*Ross ISR Project USNRC License Application
Crook County, Wyoming*

**RAI Question and Answer Responses
Environmental Report
Docket #40-09091**

Prepared by:
Strata Energy Inc.
1900 W. Warlow Drive, Bldg A
PO Box 2318
Gillette, WY 82717-2318

MARCH 2012

Figure ER RAI GEN-1-1. Ross ISR Project Current Baseline Plan View.

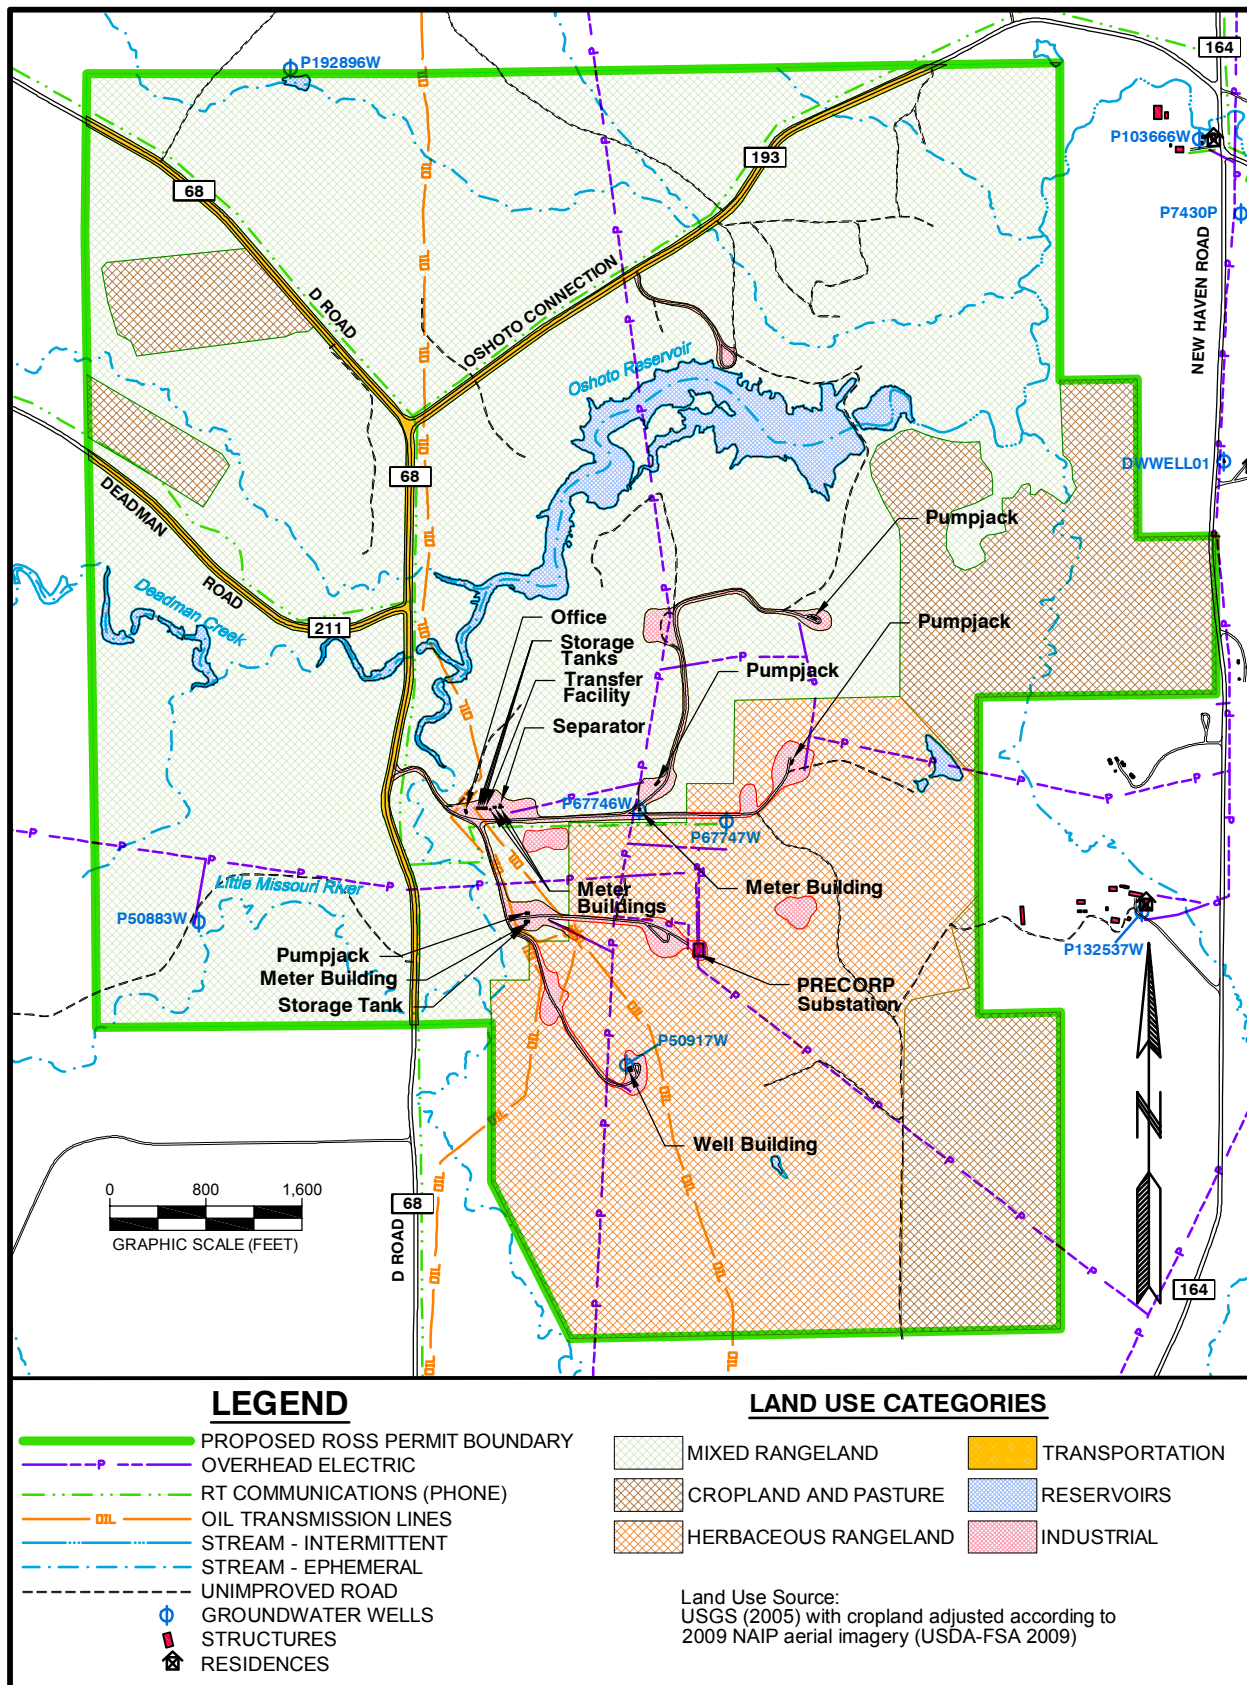
- A. *Please provide a current, baseline plan view of the existing Ross Project site, showing each of the physical (man-made) attributes listed below.*

These plan view figures should present a more regional view than Figure 1.2-5 and greater detail than present on Figures 1.2-6 and 1.2-7 in the Environmental Report (ER). In addition, these figures should be uncluttered with information not specifically requested (e.g., the mineralization areas). However, inclusion of some naturally occurring site features, such as the Oshoto Reservoir and the other water bodies such as the Little Missouri River and Deadman Creek, would enhance the clarity of the figures, as would the elimination of topographic contours in these particular views. These figures should be in an electronic format. The view of the existing, current site will serve as a baseline view and the other phased views will assist in the NRC's evaluation of Proposed Action's impacts progressively over time as required by 10 CFR Part 51.

Figure ER RAI GEN-1-1 depicts the current baseline plan view of the proposed Ross ISR Project area including land use, water bodies, streams, existing disturbance, nearby residences and infrastructure. As requested, this figure presents a more regional view of the proposed project area, including the entire proposed NRC license area, than ER Figure 1.2-5, which depicts only the CPP area.

Figure ER RAI GEN-1-2. Anticipated Facilities at the End of Construction.

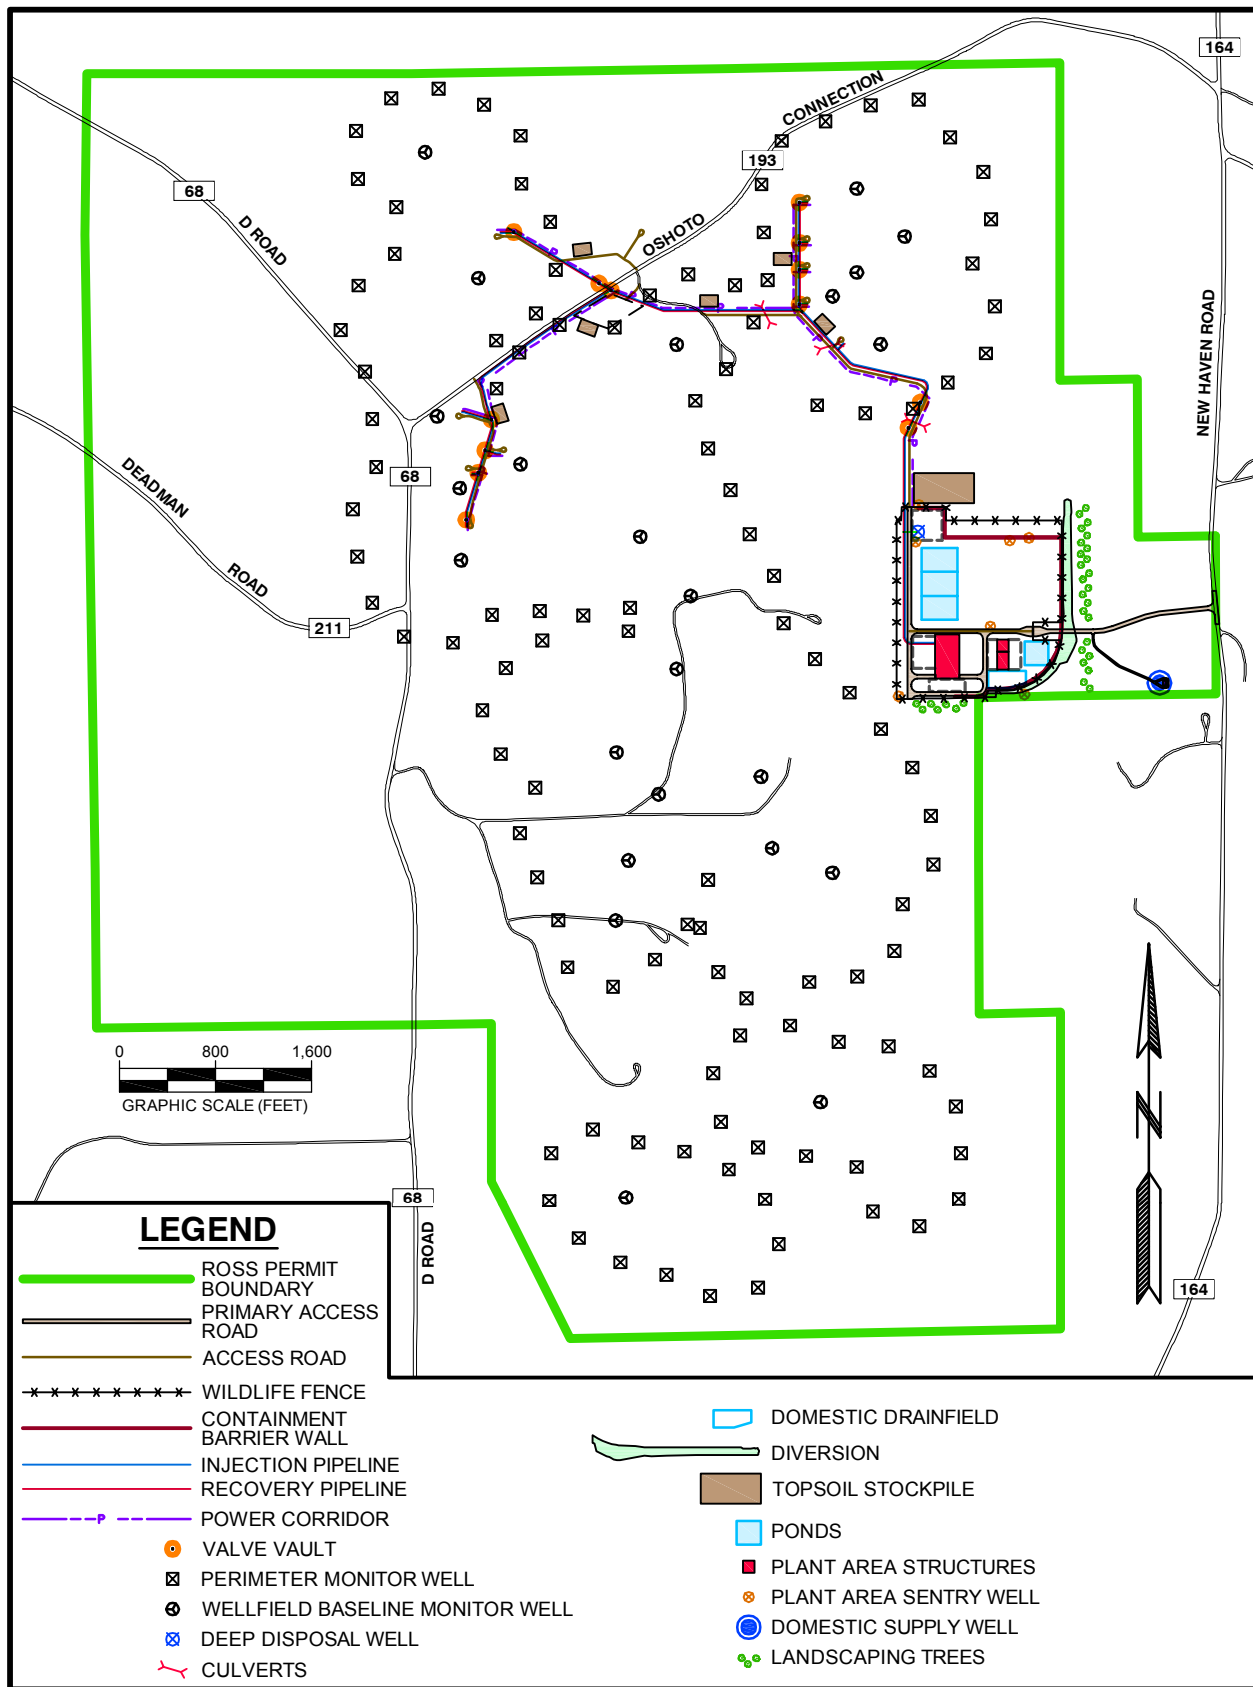
- B. Please provide a plan view of the Ross Project site using the same scale and size as the baseline plan view and showing each of the physical (man-made) attributes listed below for each phase (i.e., construction, operation, aquifer restoration, and decommissioning) of the proposed Ross Project.*

These plan view figures should present a more regional view than Figure 1.2-5 and greater detail than present on Figures 1.2-6 and 1.2-7 in the Environmental Report (ER). In addition, these figures should be uncluttered with information not specifically requested (e.g., the mineralization areas). However, inclusion of some naturally occurring site features, such as the Oshoto Reservoir and the other water bodies such as the Little Missouri River and Deadman Creek, would enhance the clarity of the figures, as would the elimination of topographic contours in these particular views. These figures should be in an electronic format. The view of the existing, current site will serve as a baseline view and the other phased views will assist in the NRC's evaluation of Proposed Action's impacts progressively over time as required by 10 CFR Part 51.

Figure ER RAI GEN-1-2 depicts the anticipated facilities at the end of facility construction. This time period is indicated in ER Figure 1.3-1 as the beginning of year 1 after regulatory approval. The facilities anticipated to be constructed include the primary access road, CPP area diversion, containment barrier wall, deep disposal well proximal to the CPP, domestic well and access road, lined retention pond 1, sediment pond, wildlife-proof fencing around the controlled area boundary, CPP, administration building and warehouse/maintenance building, and domestic drainfield. In addition, it is anticipated that the wellfield access roads, pipelines, valve vaults and power to the first mine unit will have been completed along with all of the perimeter and wellfield baseline monitor wells for both of the mine units. (Refer to ER Section 1.2.5 for a description of mine units; the wellfield modules will be divided into two mine units within the project area.) Construction and installation are also anticipated to have been completed on the module buildings in the first mine unit along with some of the production patterns; however, wellfield modules are not shown on this figure since most wellfield construction will occur after the end of facility construction.

Figure ER RAI CI-1-1. Potential Future Lance District Projects

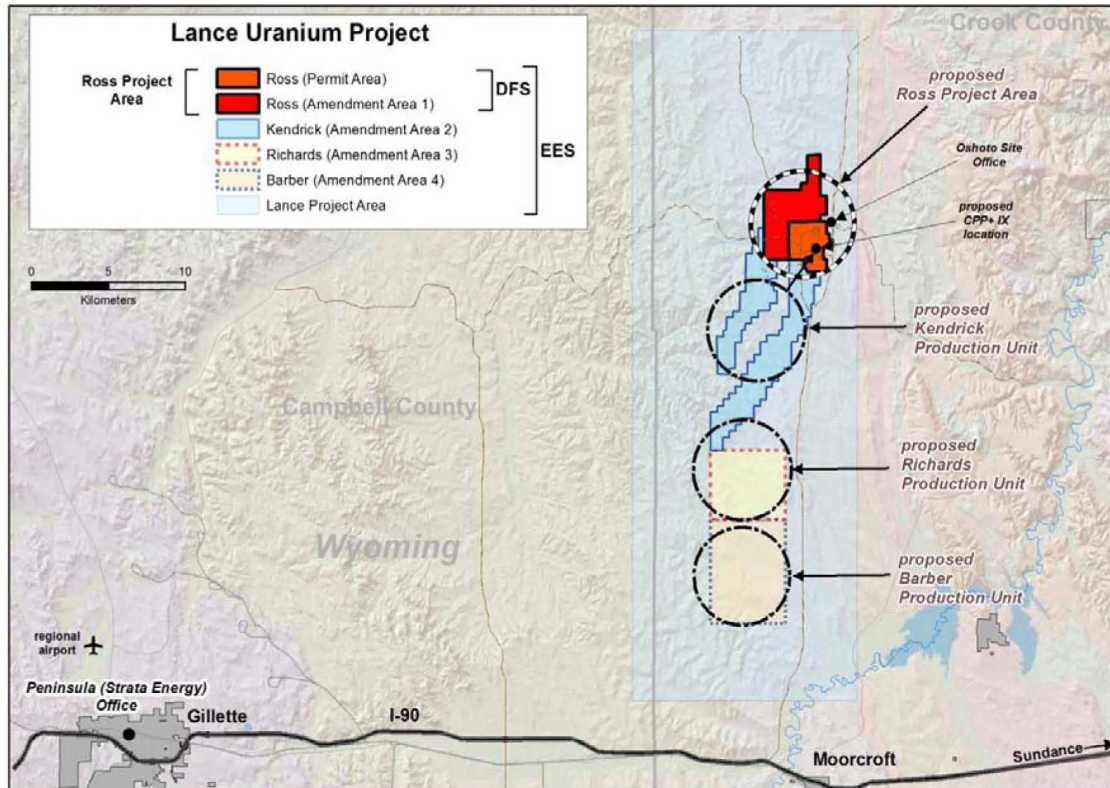
- A. *Please provide the proposed locations of the other projects relative to the Ross Project site.*

Figure ER RAI CI-1-1 depicts potential future Strata projects (license amendment areas) within the Lance District. As described in ER Section 2.2.7.1, Strata has identified significant uranium resources within the Lance District. The currently identified potential license amendment areas include an area adjacent to the proposed Ross project area (Ross Amendment Area 1), and the Kendrick, Richards, and Barber satellite facilities south of the proposed Ross project area (Peninsula 2011). Strata continues exploration drilling outside of the proposed Ross project area within the Lance District. As this exploration drilling continues, the number, location, and size of potential projects will likely change. Refer to the response ER RAI CI-1(B) for a discussion of the potential schedule of future Lance District satellite projects and to the response to ER RAI CI-2(B) for a discussion of potential cumulative impacts from these projects.

Figure ER RAI CI-1-2. Potential Lance District Development Schedule

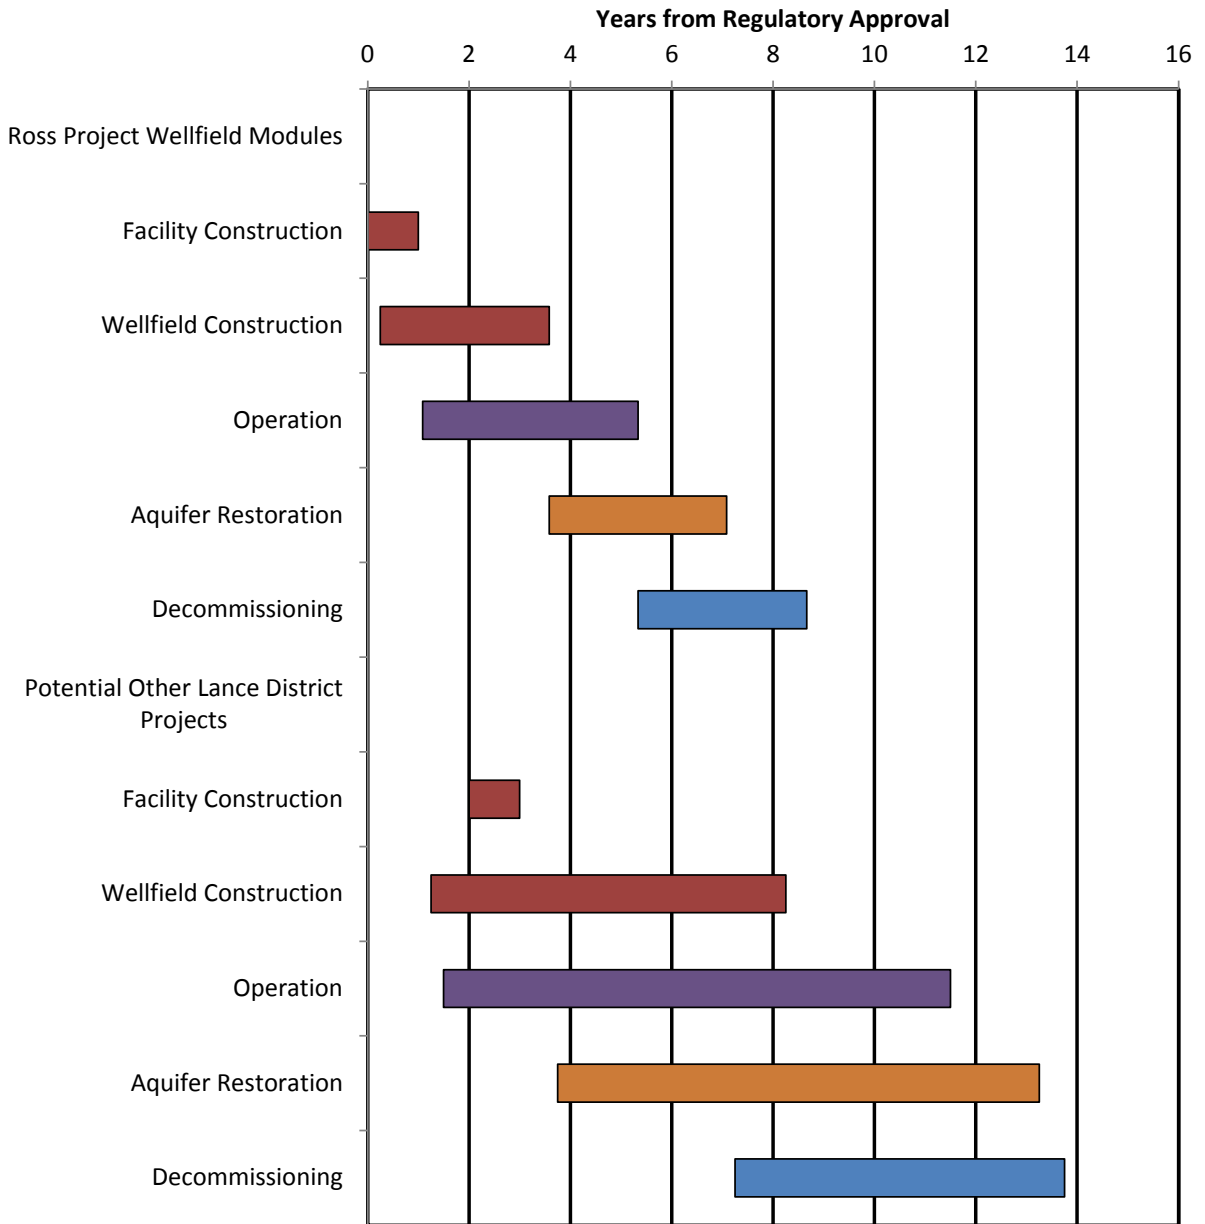
B. Please provide a schedule relative to the Proposed Action for these other projects and their activities.

Figure ER RAI CI-1-2 depicts the potential Lance District development schedule. This figure compares the potential schedule with the proposed Ross schedule as requested in the RAI. Reasonably foreseeable plans include steady-state operation of three satellite facilities. Based on potential resources in the Lance District, Strata anticipates that the total duration of ISR uranium production could be 11 to 18 years, including the Proposed Action. The potential Lance District development schedule assumes that wellfield construction in the first amendment area would begin 12 months after initial construction. The total duration of wellfield construction is estimated to be approximately 7 years. Facility construction, which would be primarily associated with the Barber Satellite Facility remote IX plant and associated ponds, is estimated to last 9 to 12 months. Operation of the amendment area wellfields is anticipated to last 10 to 17 years. Aquifer restoration is anticipated to begin approximately 2 to 2.5 years after the start of operation and last approximately 9 to 16 years. As with the Proposed Action, significant overlap is anticipated between operations and aquifer restoration, since aquifer restoration of individual wellfield modules would begin almost immediately
